*Application No.: 10/624,208
Amendment*

AMENDMENTS TO THE DRAWINGS

Please replace Figures 1D, 1E, 2A, 2C, 3, 5, 7, 12, 13, 14 and 17, with the attached Replacement Sheets. Annotated marked-up drawings are also provided that identify the changes in the above noted Figures.

**FIG 1D****FIG 1E**

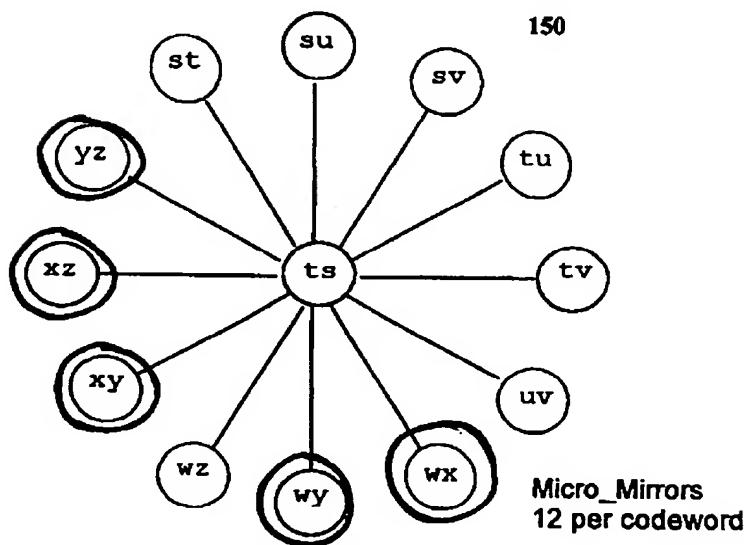
In the drawings, a number of replacement sheets are submitted to correct typographical errors or to enhance the readability of the figures. All of the drawing figure changes, with the exception of Figure 1E and 3, have been amended to look as they did in United States Provisional Patent Application Nos. 60/399,635 entitled “Data Dispersion and Mirroring Method

With respect to Figure 1E, the changes are supported by at least the text in paragraphs 0077 through 0080.

FIG 3

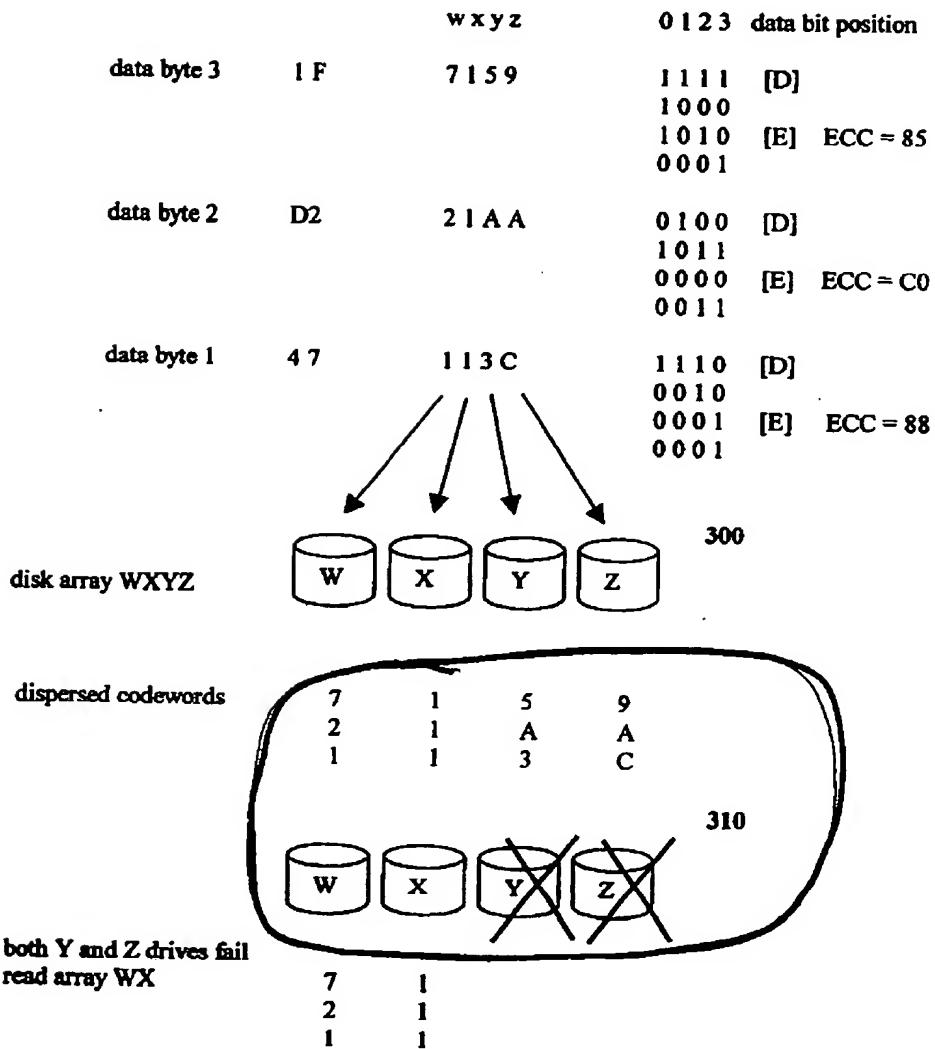
With respect to Figure 3, the changes are supported by at least the text in paragraph 0062.
